O-D DOCUMENTATION		SEARCH ANALYSIS	
REQ'D	NOT REQ'D	REQ'D	NOT REQ'D
SHOP TAB		FIELD TAB	
START OF NG		COST CODE	INSTR. CL.
1. TAC		5534	F
PLAN		PLAN DESIGN DWG	
M-157.5N1		SP-27-3	
UNIT	ELEV	AREA	
	683-0		27

BECHTEL POWER CORPORATION
BERWICK, PENNSYLVANIA / SAN FRANCISCO, CALIFORNIA

PENNSYLVANIA POWER & LIGHT COMPANY
ALLENTOWN, PENNSYLVANIA
SUBSIDIARY OF THE PENNSYLVANIA POWER & LIGHT COMPANY, UNIT 1, UNDER

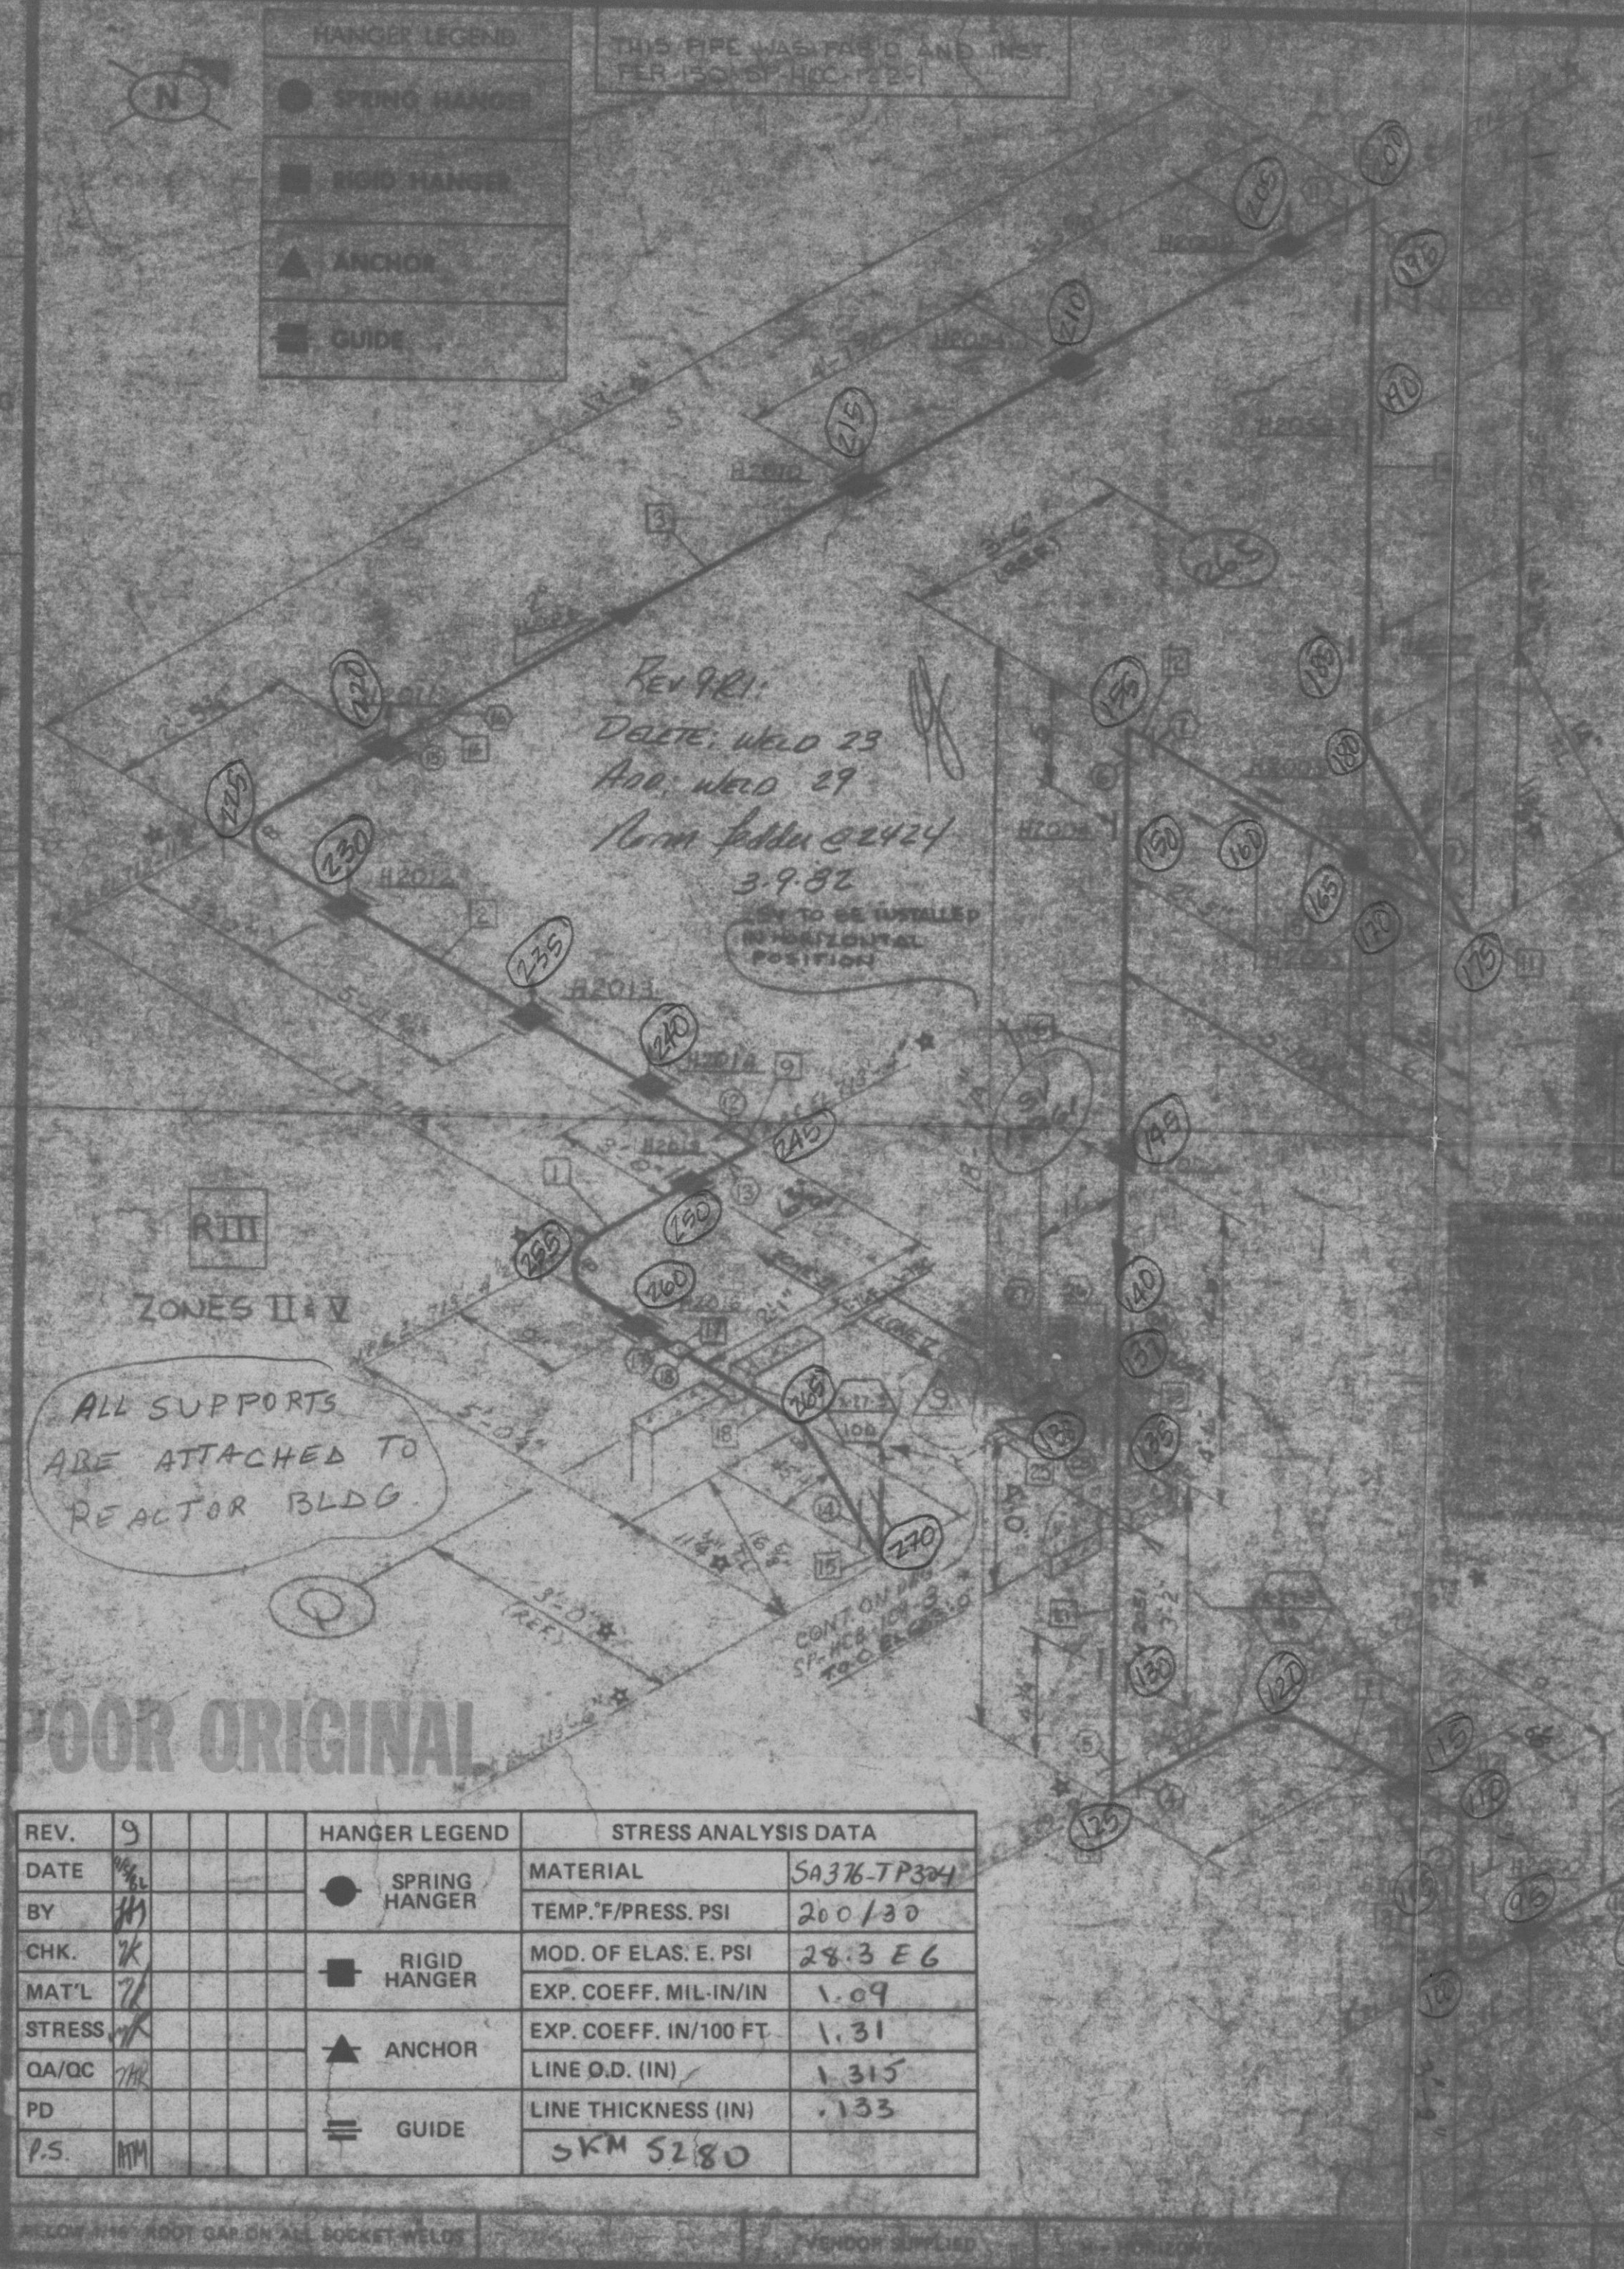
NOTES
 DELETED WELD 1
 ADDED WELOS 11-THRU-15
 ADDED PC 10-THRU-13

REV A NOTE:
 INCORP REDLINE
 DELETE FW 18
 ADD FW 20

REV A NOTES:
 CHANGE SV-157548 AND
 SV-157549 TO SV-157548 AND
 SV-157549 PER ENG 7180

REV. 2 NOTES:
DELETE WELDS 21 & 22
ADD WELD 23

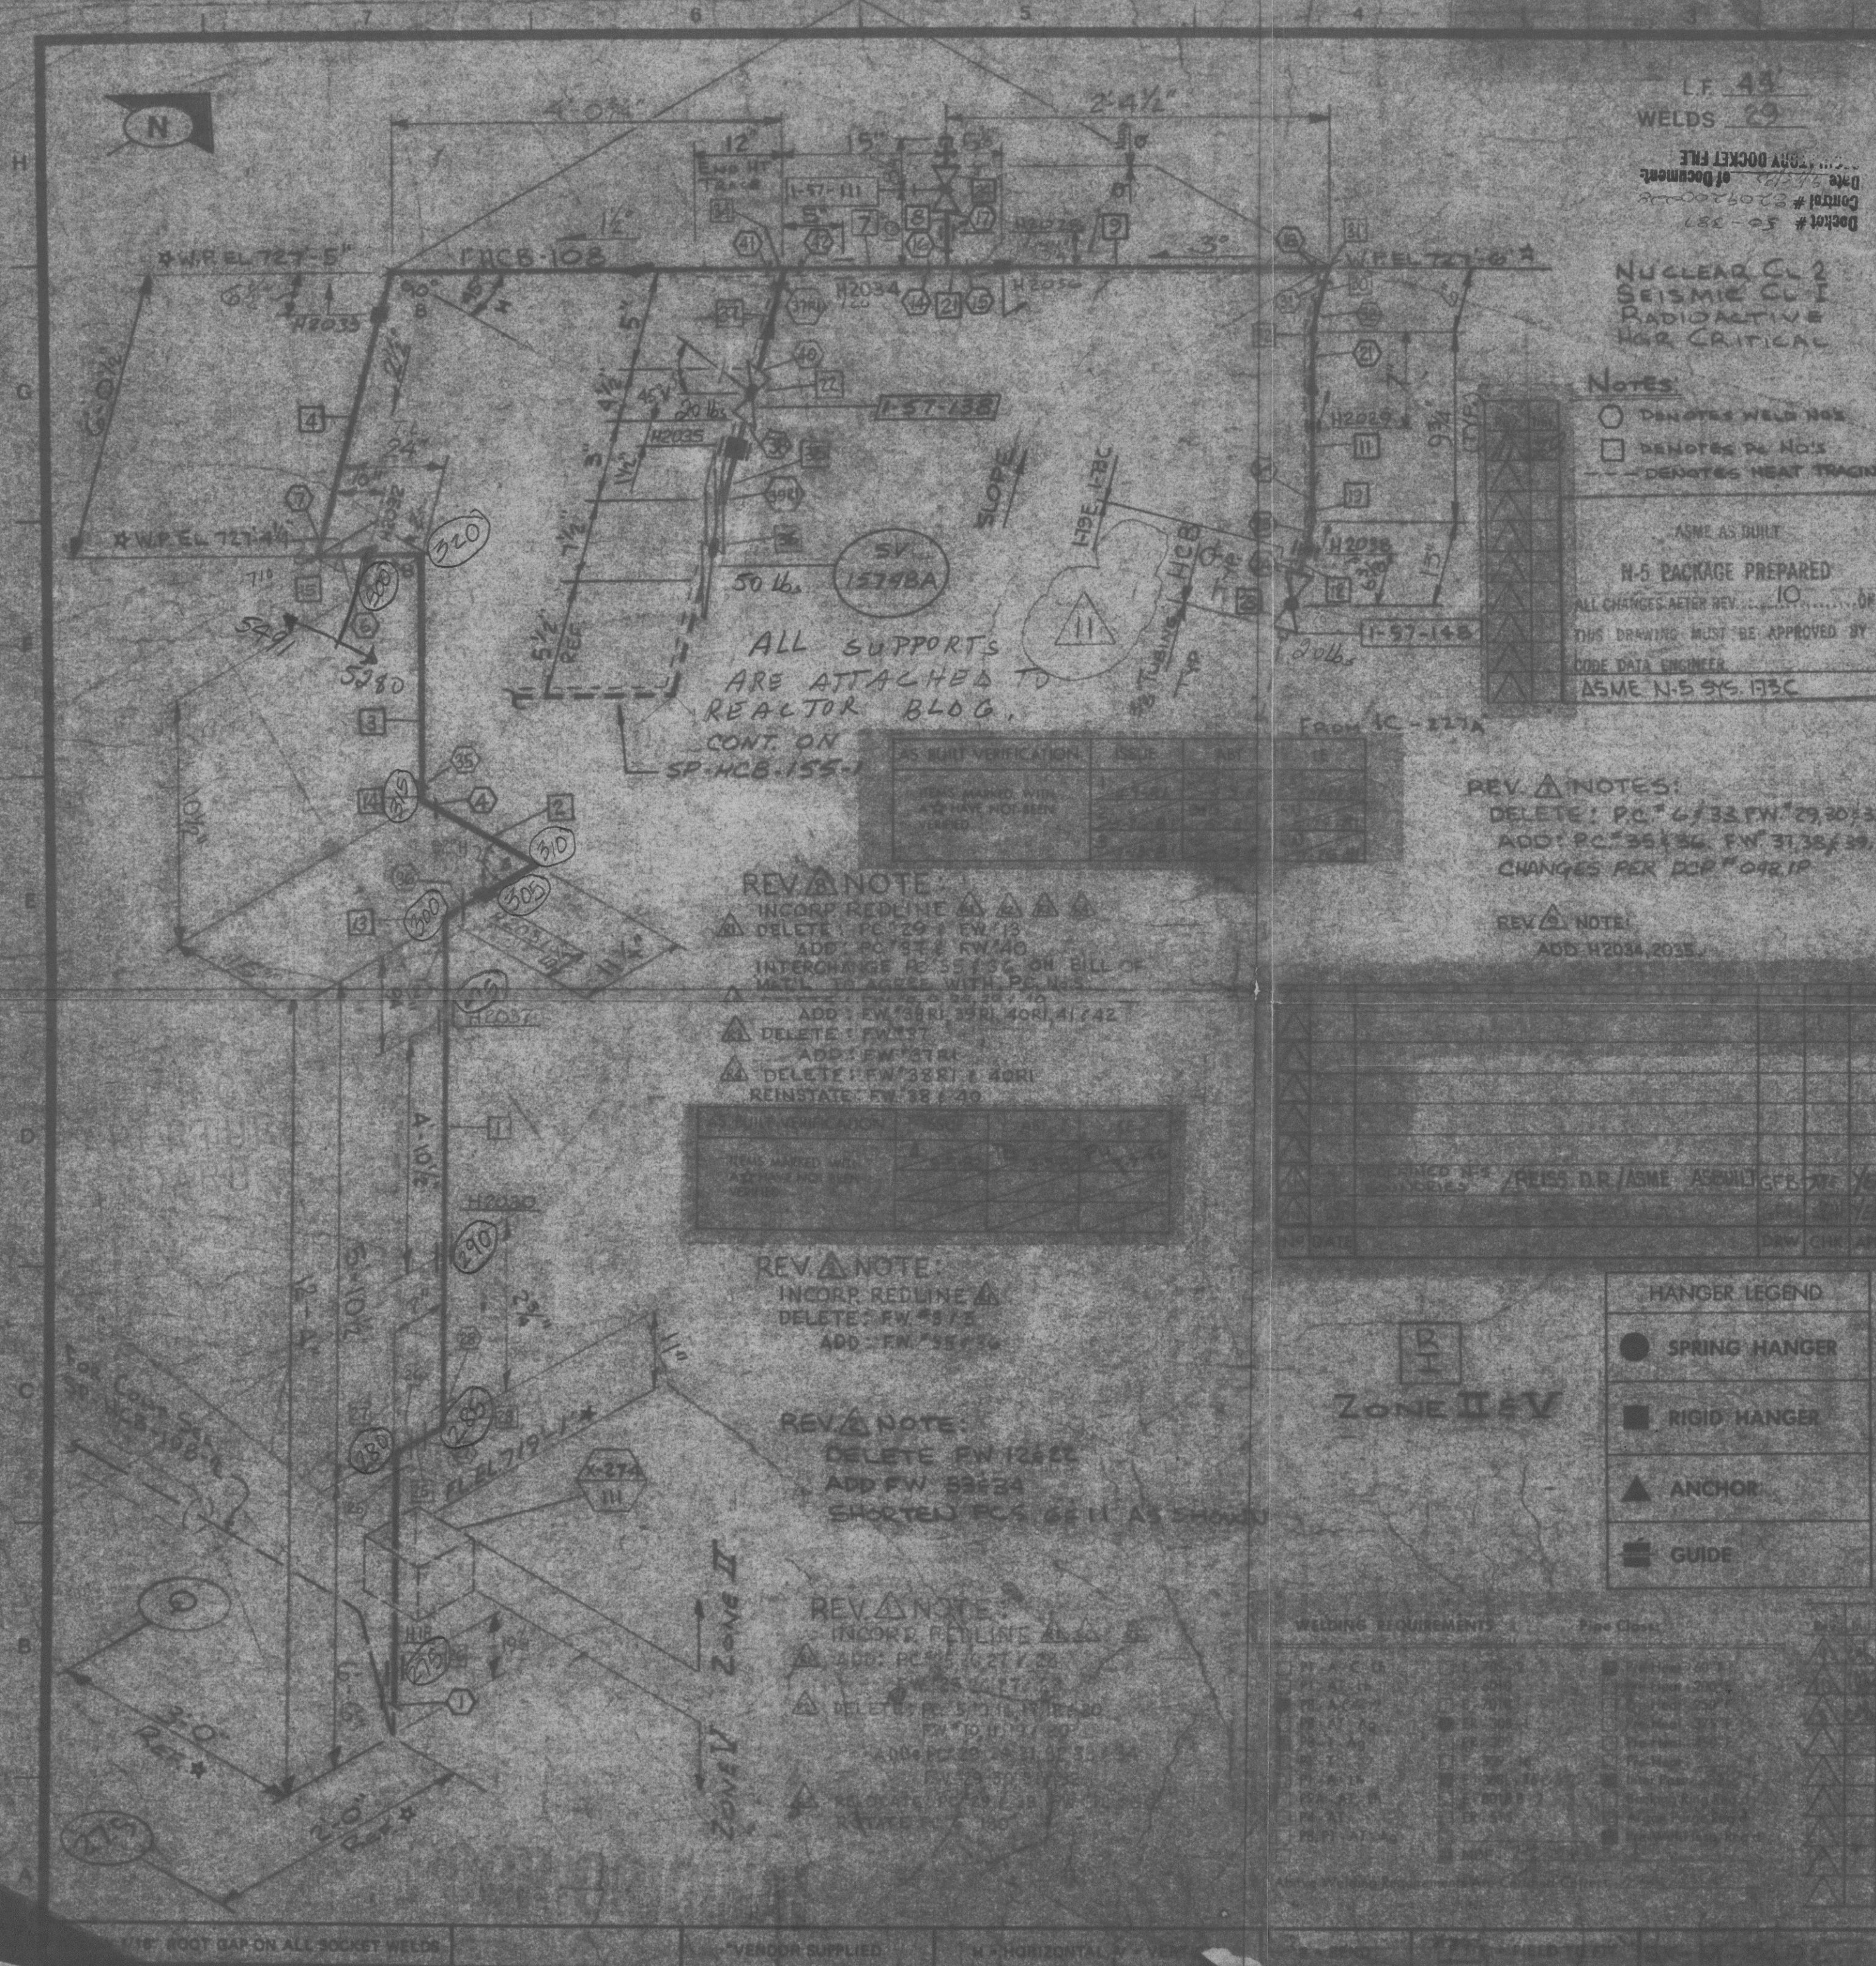
REV. A NOTES:
DELETE: PC 4/33 FW 29, 30, 33
ADD: PC 35, 36, FW 31, 38, 39
CHANGES PER DCP 0481P

REV. A NOTE:
ADD H2034, 2035

REV. A NOTE:
INCORP. REDLINE
DELETE: PC 29, FW 13
ADD: PC 35, FW 40
INTERCHANGE RE 55, 56 ON BILL OF
MATERIAL TO AGREE WITH PC NOS.
ADD: FW 38RI, 39RI, 40RI, 41, 42
DELETE: FW 37
ADD: FW 37RI
DELETE: FW 38RI, 40RI
REINSTATE: FW 38, 40

REV. A NOTE:
INCORP. REDLINE
DELETE: FW 8/3
ADD: FW 35, 36

REV. A NOTE:
DELETE FW 12, 13
ADD FW 33, 34
SHORTEN FCS 62 II AS SHOWN
